8-A-17-SC - cor_ City Eng

SUBJECT: Closure of a portion of W Oklahoma Ave
MPC File # 8-A-17-SC;
City Block 11361 and 11043

**Re: Right-of-Way Closure Request 8-A-17-SC
Block No. 11361
CLT No. 81
Parcel No. 081NH008**

File No. 8-A-17-SC W. Oklahoma Ave. btwn N. Central St. and parcel 081NH004 (Gas)

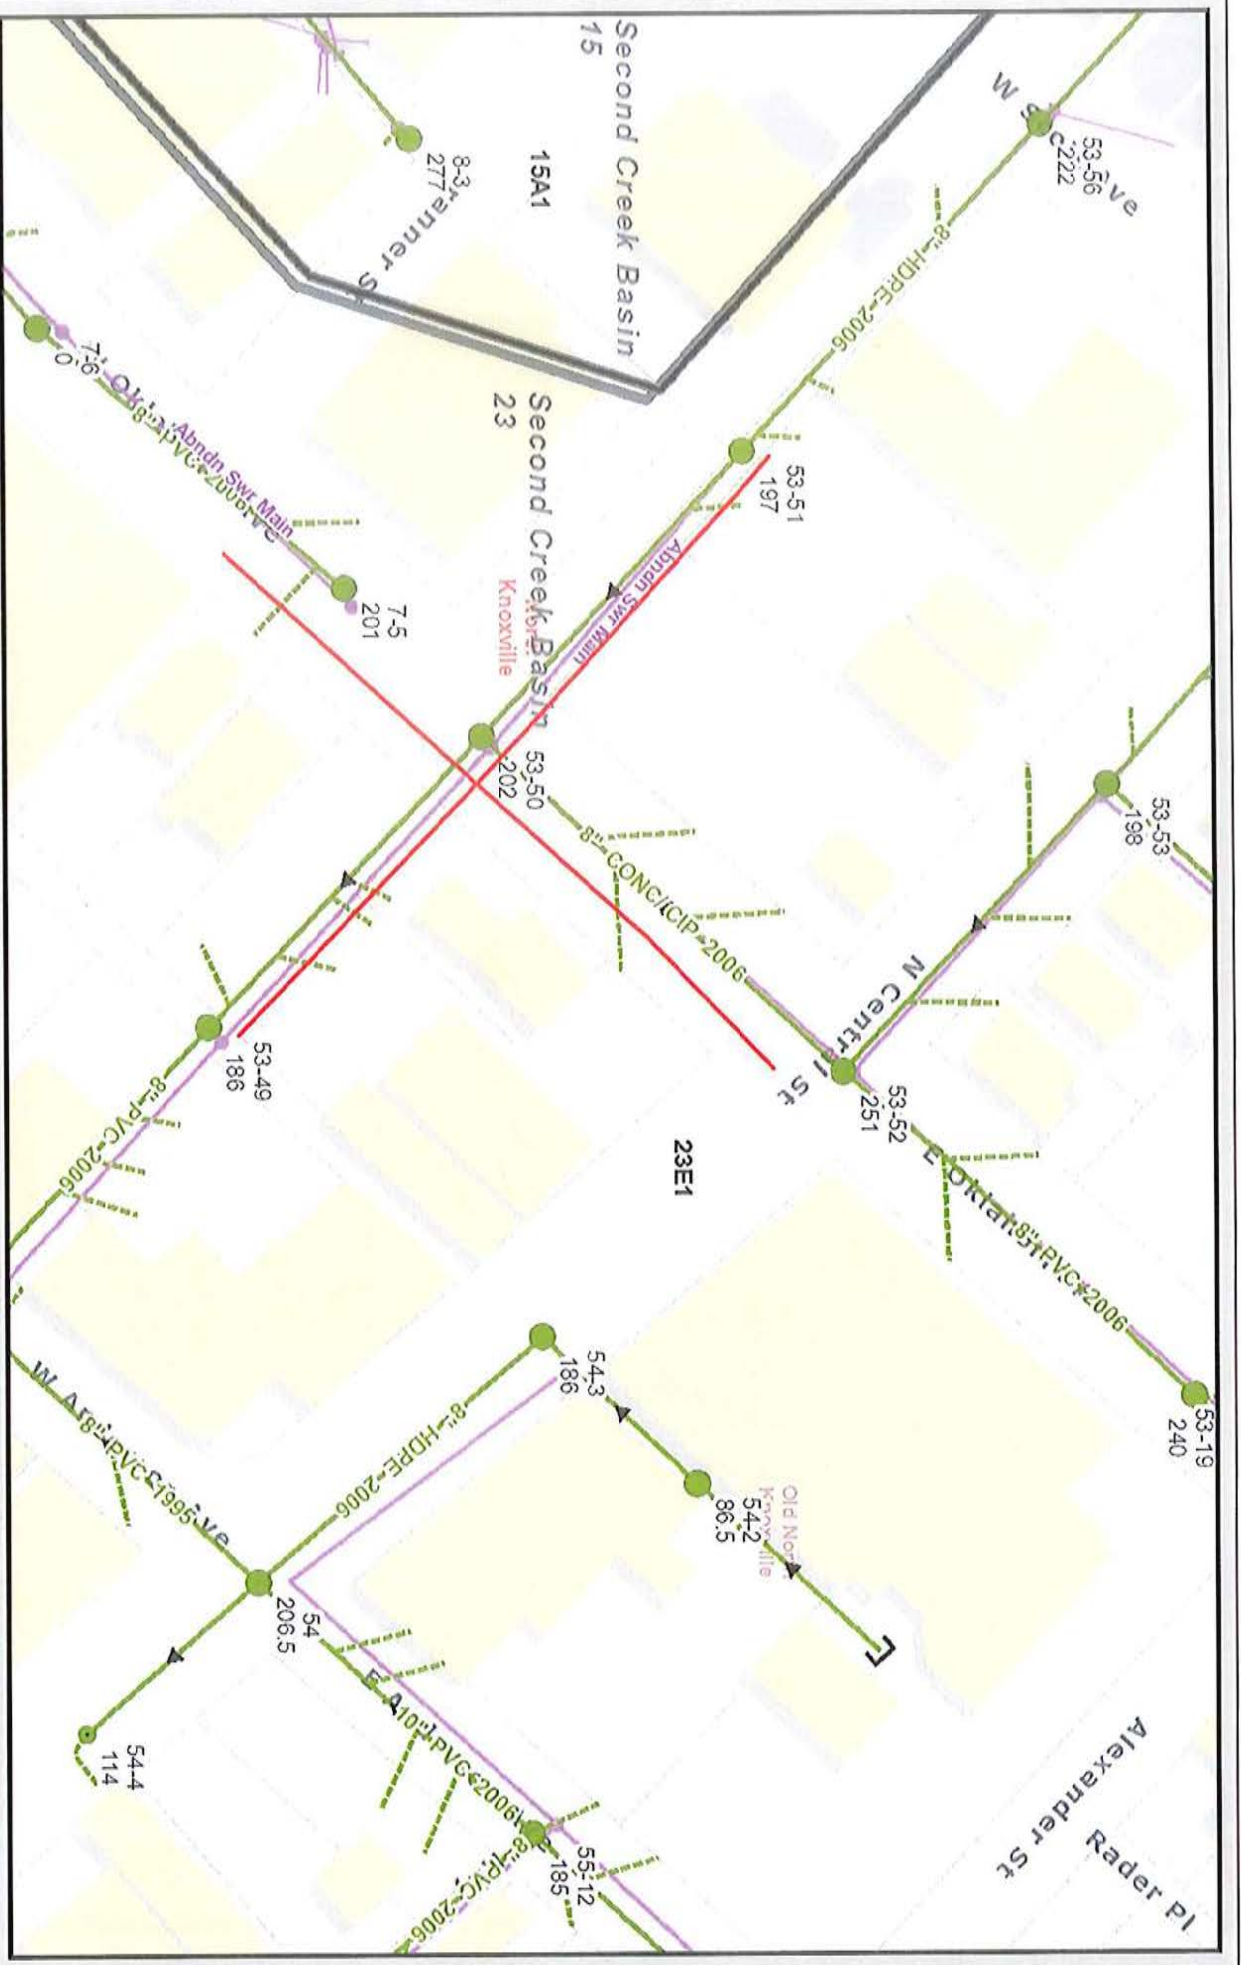
We have reviewed our records and find that we have existing utility facilities located within the subject right-of-way. The approximate location of these facilities is indicated on the enclosed prints. However, KUB does not release and hereby retains all easements and rights for existing utility facilities, whether or not shown on these prints.

Should this right-of-way be closed, KUB will require the following permanent easement for its utility facility.

- Electric – 10 feet on each side of the centerline of the electric line, 20 feet total width
- Gas – 7.5 feet on each side of the centerline of the gas line, 15 feet total width
- Sewer – 7.5 feet on each side of the centerline of the wastewater line, 15 feet total width
- Water – 7.5 feet on each side of the centerline of the water line, 15 feet total width
